## Product Change Notice (PCN)

PCN Number: PCN-0451129R-01

Product(s) Affected: PJ-031D & PJ-031DH

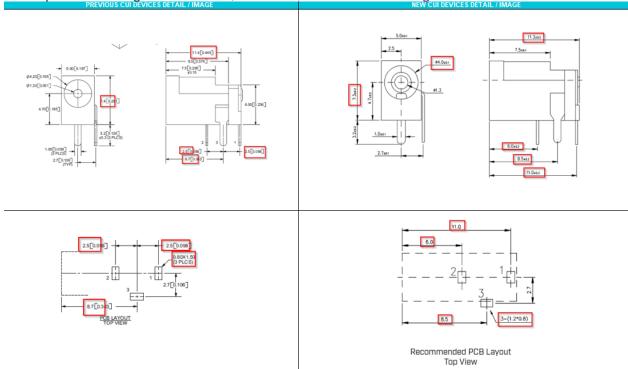
Description of Change: Mechanical, electrical, and material changes as shown below:

MATERIAL	PLATING
center pin	copper	nickel
terminal 1	brass	silver
terminal 2	copper alloy	silver
terminal 3	brass	silver
plastic	PBT

DESCRIPTION	MATERIAL	PLATING/COLOR
center pin	brass	silver
terminal 1	brass t=0.50	silver
terminal 2	MM alloy t=0.20	silver
terminal 3	brass t=0.50	silver
housing	PA10T (UL94V-0)	black
